Access Compliance Report

Public Rights-of-Way

(Curb Ramps)

Intersection ID: 30374	Main Street: EASTWAY_CROSSING_DR	Cross Street: EASTWAY_DR	Location: SW
ADA ID: 171F9A8825EA	Ramp Type: Perp	Initial Pass/Fail: Fail	Overall Compliance: No
		Severity Score: 12.5

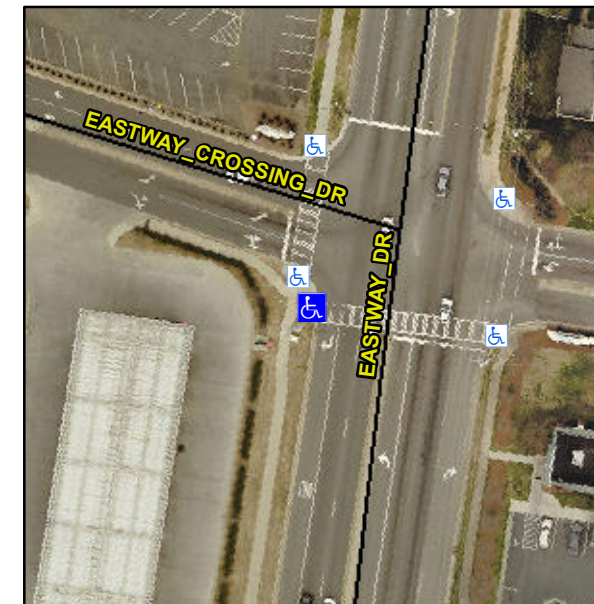
Not Found, R304.2.2

Compliance	Description	Data	Compliance	Description	Data
N/A	Ramp Length (in)	102.5	No	Ramp Slope (%)	8.7
Yes	Ramp Width (in)	72.0	Yes	Ramp XSlope (%)	1.4
N/A	Flare Type LT	N/A	N/A	Flare Type RT	N/A
N/A	Flare Slope LT (%)	N/A	N/A	Flare Slope RT (%)	N/A
N/A	Flare Traversable LT?	N/A	N/A	Flare Traversable RT?	N/A
N/A	Landing Length (in)	N/A	N/A	DWS Provided?	N/A
N/A	Landing Width (in)	N/A	N/A	DWS Contrast?	N/A
N/A	Landing Slope (%)	N/A	N/A	DWS Length (in)	N/A
N/A	Landing X Slope (%)	N/A	N/A	DWS Full Width?	N/A
N/A	Landing Curb? (Y/N)	N/A	N/A	DWS Offset (in)	N/A
N/A	Shared Landing?	N/A			
N/A	Gutter Ponding?	N/A	N/A	Gutter Slope (%)	N/A
N/A	Gutter Lip Ht (in)	0.5	N/A	Gutter X Slope (%)	N/A
N/A	Painted X Walk1?	Yes	N/A	Painted X Walk2?	N/A
	X Walk 1 Direction	To E		X Walk 2 Direction	N/A
N/A	X Walk 1 Width (in)	110.0	N/A	X Walk 2 Width (in)	N/A
	X Walk 1 Slope (%)	3.3		X Walk 2 Slope (%)	N/A
	X Walk 1 X Slope (%)	2.0		X Walk 2 X Slope (%)	N/A

Remove & Replace Entire Ramp.
